SERVICE BULLETIN

B-065

ULYSSES SERVICE LITERATURE UPDATE

Fuses, Relays and Diode: 2006, 2007 Ulysses XB12X

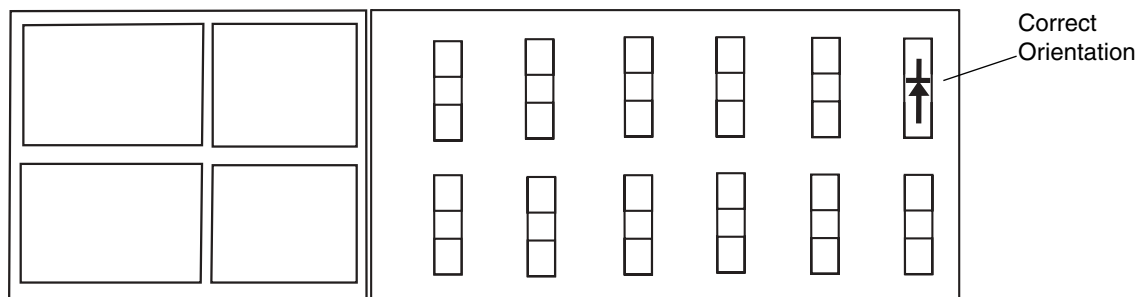
The orientation of the removable diode in the fuse block was shown incorrectly in the 2006 and 2007 XB12X Ulysses owner's and service manuals. If the diode is installed in this orientation the vehicle will only start with the clutch lever pulled in, even with the transmission in neutral.

Notify customers and service personnel of service bulletin. Recent 2007 XB12X owner's manuals will have a corrected fuse block figure as shown in this bulletin. Please correct this figure in 2006 and 2007 owner's and service manuals in your dealer stock. Following is a list of manuals and affected pages.

- **2006 XB12X Ulysses Model Owner's Manual Part No. 99477-06Y**
Page 112 Figure 48
- **2007 XB12X Ulysses Model Owner's Manual Part No. 99477-07Y**
Page 106 Figure 45
- **2006 XB12X Ulysses Model Service Manual Part No. 99494-06Y**
Page 5-11 Figure 5-5
- **2007 XB12X Ulysses Model Service Manual Part No. 99494-07Y**
Page 5-11 Figure 5-5
